Application B: 1 Paul's Walk (20/00235/FULL).

From: Thomas See
Sent: 05 April 2020 21:27
To: Devlia, Neel; Chipperfield, Rob; PLN - Comments
Subject: RE: 20/00214/FULMAJ and 20/00235/FULL
Attachments: Letter of objection 5Apr20.docx; Anstey Horne report on daylight and sunlight 2Apr20.pdf

RE: 20/00214/FULMAJ Application for refurbishment and extension of Millennium Bridge House, 2 Lambeth Hill, London, EC4V 4AG

RE: MILLENNIUM BRIDGE HOUSE AND NORFOLK HOUSE – RESPONSE TO PLANNING OBJECTION FROM NHRL/ ANSTEY HORNE

Figure1: sketch of Roadway showing proposed building on and around the Roadway

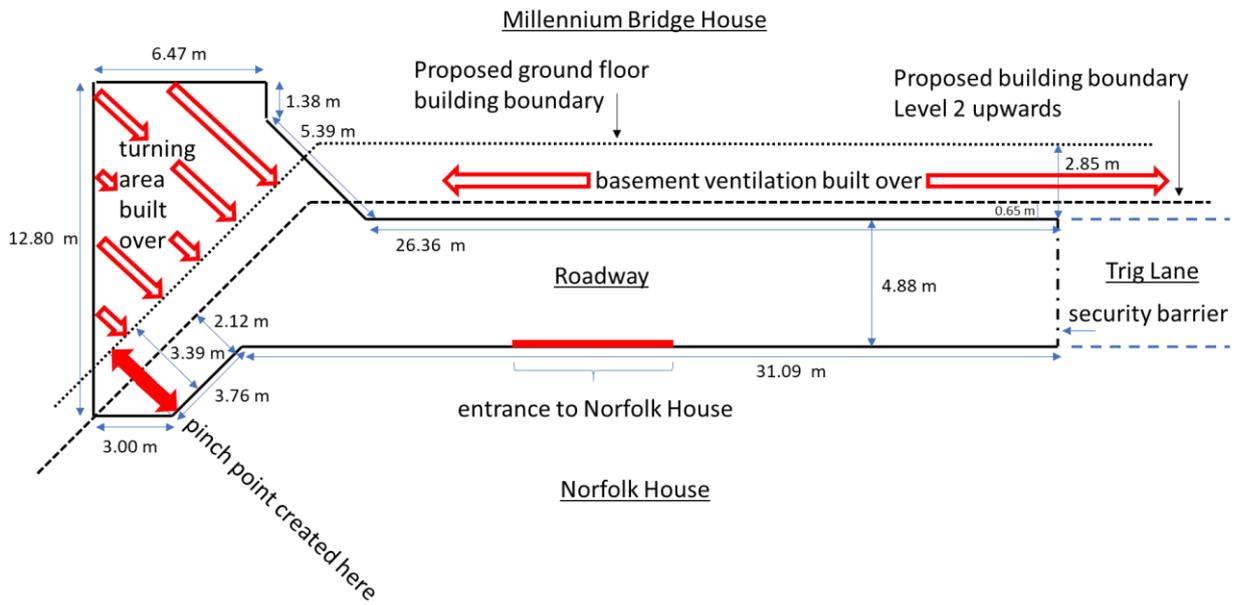
4a. No acceptable provision has been made by the Applicant to give equally convenient vehicular access to Norfolk House residents to load and unload directly in front of Norfolk House’s main entrance and to turn vehicles around within this roadway so vehicles can re-join Trig Lane in forward gear. We prepared a plan (Figure 1 below) and photographs (Figures 2 to 5) based on the Applicant’s proposal. This shows how the Applicant proposes to build over the turning area in the existing Roadway (which adjoins Trig Lane) in a way that will make it impossible for Norfolk House to continue to have equally convenient access and egress, even were the Applicant to propose including roadway access to the entrance to Norfolk House, which the Applicant has not done.

(Please note that Figures 1 – 5 were prepared informally by residents, to help visualise the Applicant’s plans, as contained in the Applicant’s presentation. We have tried to locate key points in these figures as closely as possible to the Applicant’s drawings although some dimensions were not given and which we estimated to locate key points. Any slight error in positioning should not detract from the observations we are making.)

NGL 731070

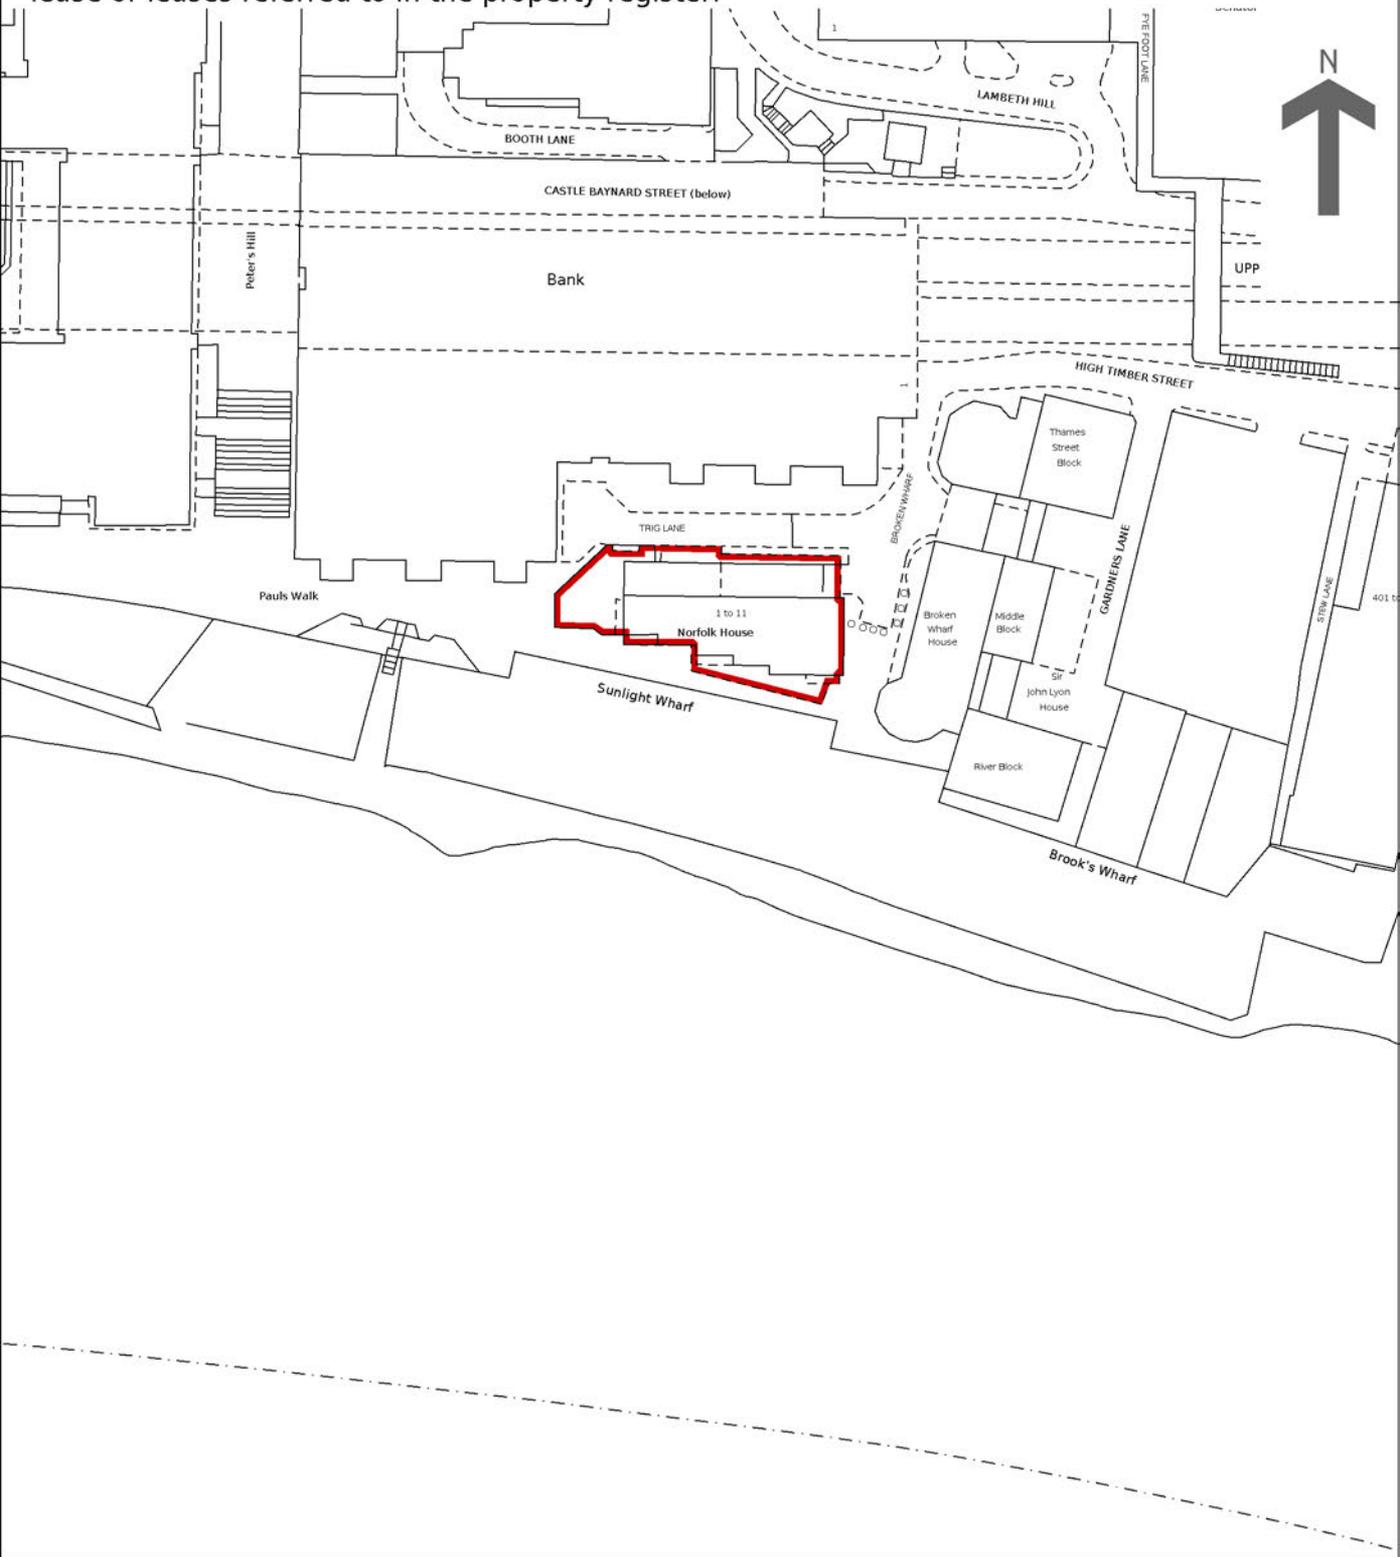
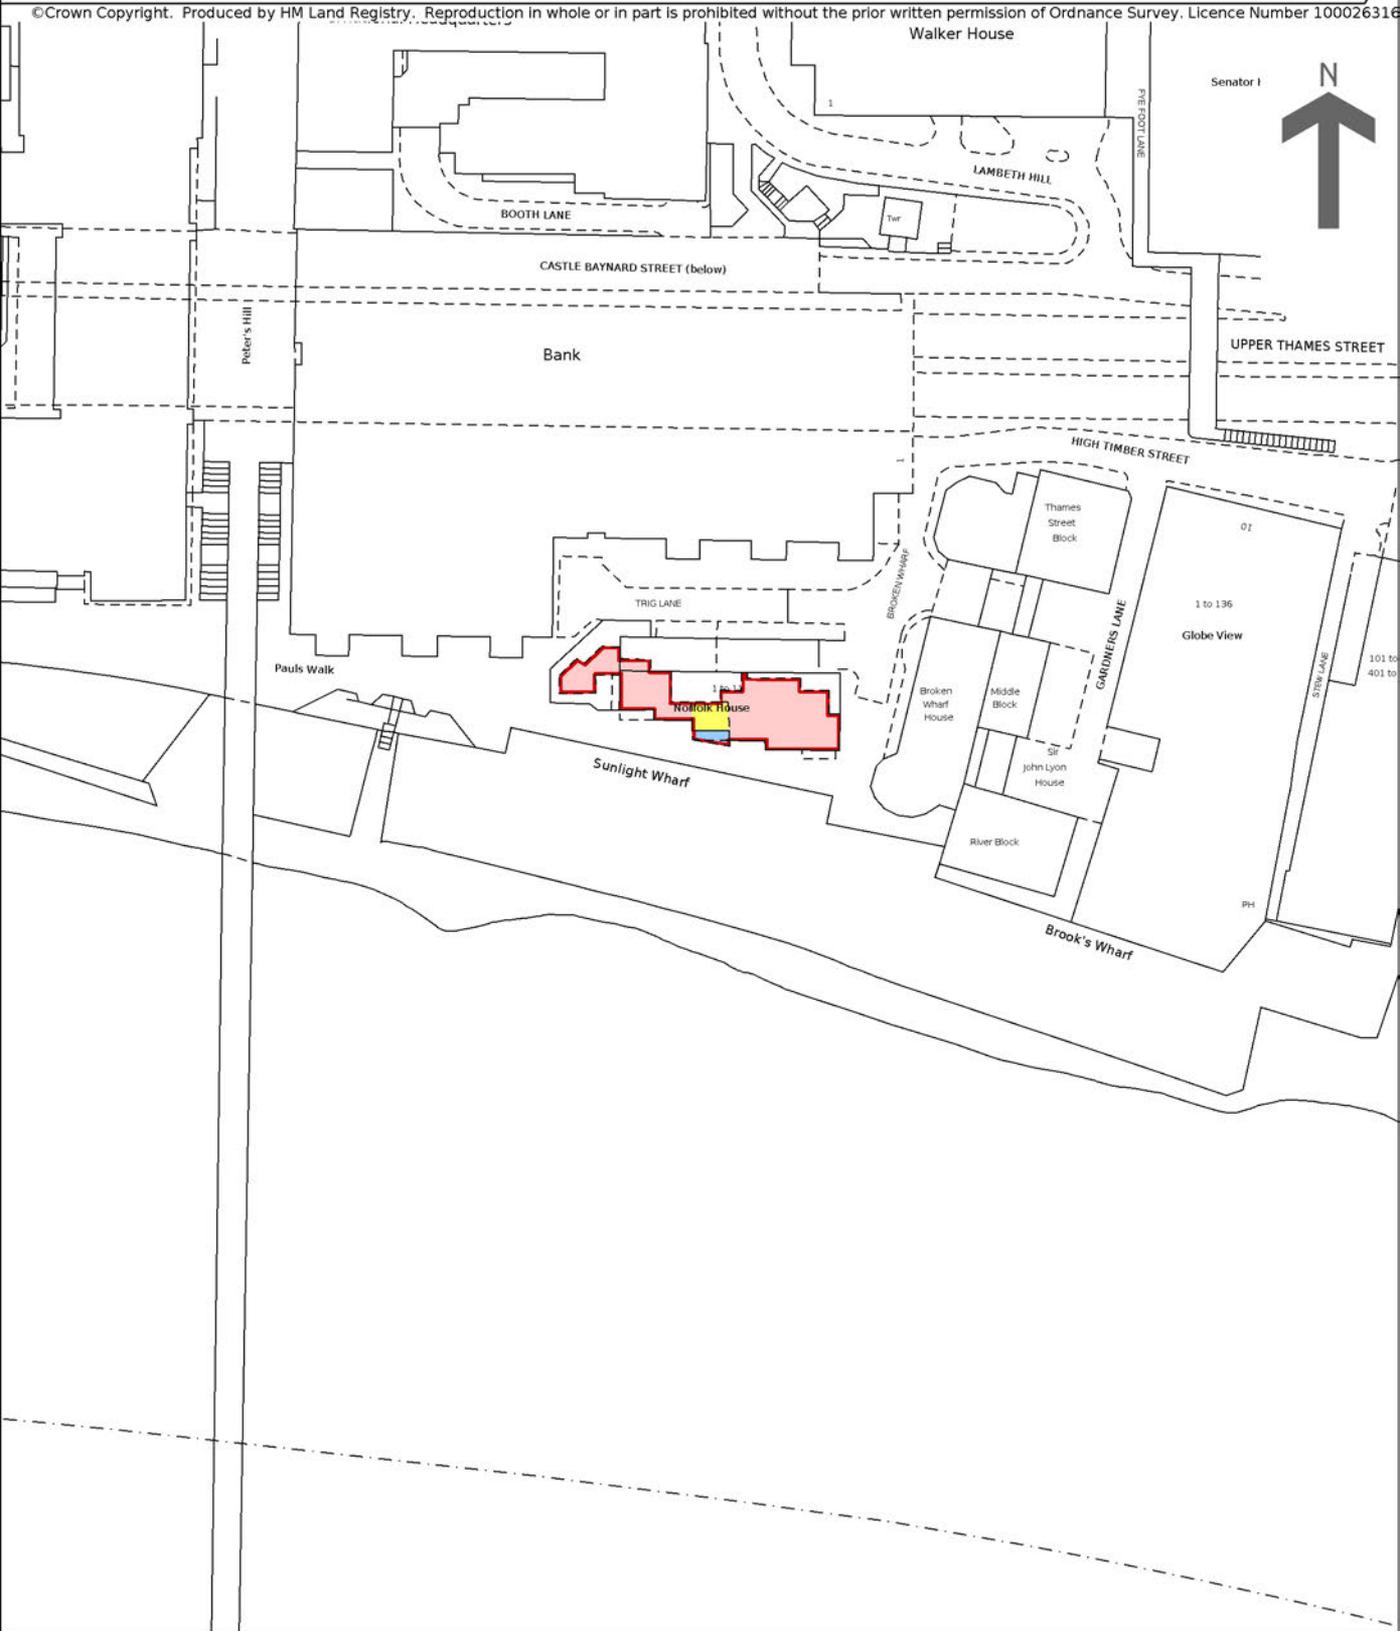
Despite claims to the contrary in the Applicant’s letter dated 12 June 2020, there is no legal ambiguity over the control exercised by NHRL over the Podium. The attached Land Registry plan for NGL731070 shows the extent of NHRL’s demise of the Podium area at ground floor level. It shows that NHRL’s demise extends over the whole area of the raised Podium, which wraps around Norfolk House and extends to one side of the Roadway adjoining Trig Lane. NHRL is granted rights of support for the Norfolk House premises, which include the raised Podium area. A smaller section within the surface area of the Podium is demised to the Norfolk House Restaurant but this area does not extend to the outer edges of the podium (so that there is an area around the outer edges of the surface of the Podium which remains in NHRL’s control). This is shown in the Land Registry plan for title number NGL801549. Further, and significantly, the walls, rails and surrounds of the Podium are specifically excluded from the Restaurant lease. NHRL’s legal control over the Podium cannot be overcome as the (a) the structure of the Podium is outside of the restaurant’s demise and (b) even if it were within the restaurant’s demise, the lease prohibits any alteration to the structure of the Premises. The rights of support enjoyed by NHRL means that the Podium cannot be lowered.

Figure 1 – Public Highway Boundary to Trig Lane

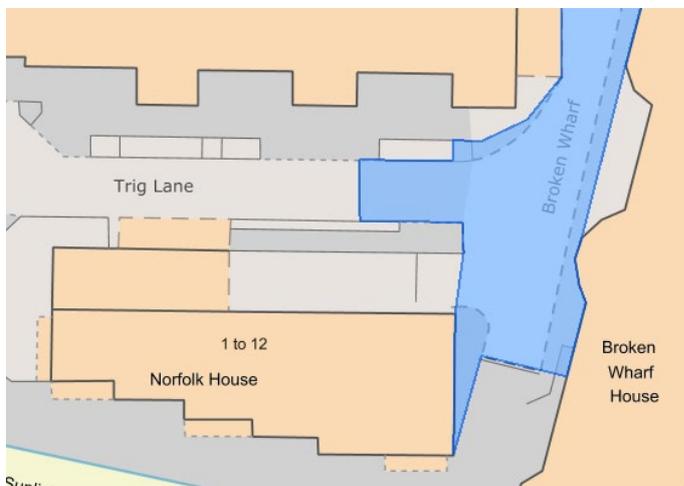
(4b.) Trig Lane is not public highway beyond the bollard. The deliveries and servicing of Norfolk House are not the subject of this application and the existing informal arrangement which is not controlled by any planning conditions would be maintained. Existing vehicle deliveries to Norfolk House are not undertaken in a forward in forward out arrangement as vehicles are not able to turn around in the existing condition, vehicles are required to reverse in or out.

Trig Lane is not public highway beyond the bollard and the T shaped junction in front of the bollard is designated as public highway with a double yellow line. This area designated as public highway is shown at figure 1.

Figure 2 – Fire Access Arrangement to Norfolk House

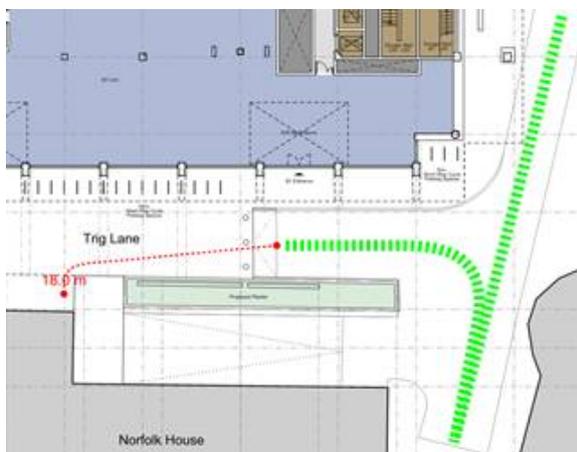
5c. By increasing the size of their building, the Applicant significantly reduces the already limited distance between the raised Podium of Norfolk House and their planned development. This expansion stops the Fire Brigade from not only efficiently accessing Norfolk House and the new development on the Thames side, but also the lower area of the Millennium Bridge and the adjacent school.

(5a.& b.) Fire service access will be available to within 18m of the dry riser inlet serving Norfolk House. Turning is available using the hammer head provided by Trig Lane and Broken Wharf shown at figure 2.

This arrangement is compliant with Building Regulations Approved Document B (Fire Safety) guidance.

Flat 11

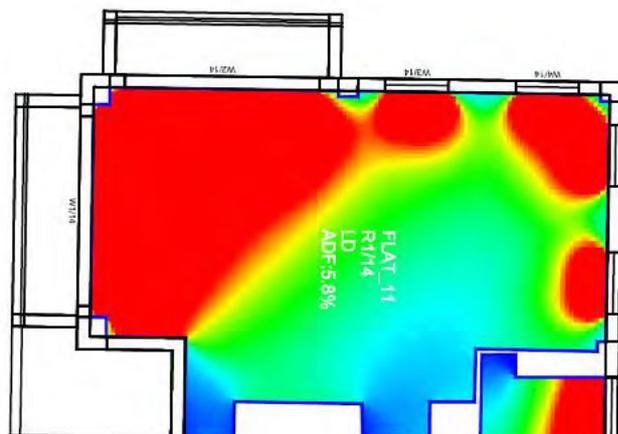
Where there is an open plan living space extending from the north to south elevations of Norfolk House, I have explained earlier why I do not think it is fair and reasonable to argue that the southern elevation glazing is the main source of light to the whole space. That is to ignore the impact upon the northern windows to these open plan spaces and I do not believe be correct.

1. There are six windows serving the LKD. The south facing window overlooking the River Thames is a full height, full width window measuring 4.5m x 3m. There is a second, equally sized windows that faces west. The north facing windows are 1.45m x 1.41m.
2. The existing VSC value for the south and west facing windows are significantly higher than the north facing windows. This fact, coupled with the larger window dimensions clearly dictates that the south facing window provides more daylight than the north facing windows.
3. The radiance plot below clearly demonstrates that much higher daylight factors are received through the river facing windows by comparison to the north facing windows. This is demonstrated by the brighter colours. The south facing windows are on the left of the image whereas the north facing windows are on the right.

It therefore seems clear to me that the south facing windows are the primary source of light and so I do not accept AH's suggestion otherwise.

Flat 1

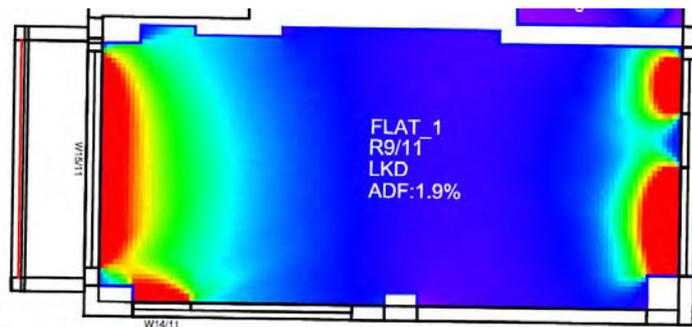
- This is an important point, because Point 2 make their initial assumption about the open plan arrangement and therefore effectively dismiss certain spaces as being BRE adherent when that may not in fact be the case. An example may be Flat 1 at first floor level.

1. The south facing window overlooking the River Thames is a full height, full width window measuring 4.5m x 2.275m. The north facing windows are 1.1m x 1.41m and 2.2m x 1.4m.
2. The existing VSC value for the south facing window is higher than the north facing windows.
3. The radiance plot below clearly demonstrates that daylight penetrates much further into the room through the river facing windows by comparison to the north facing windows.
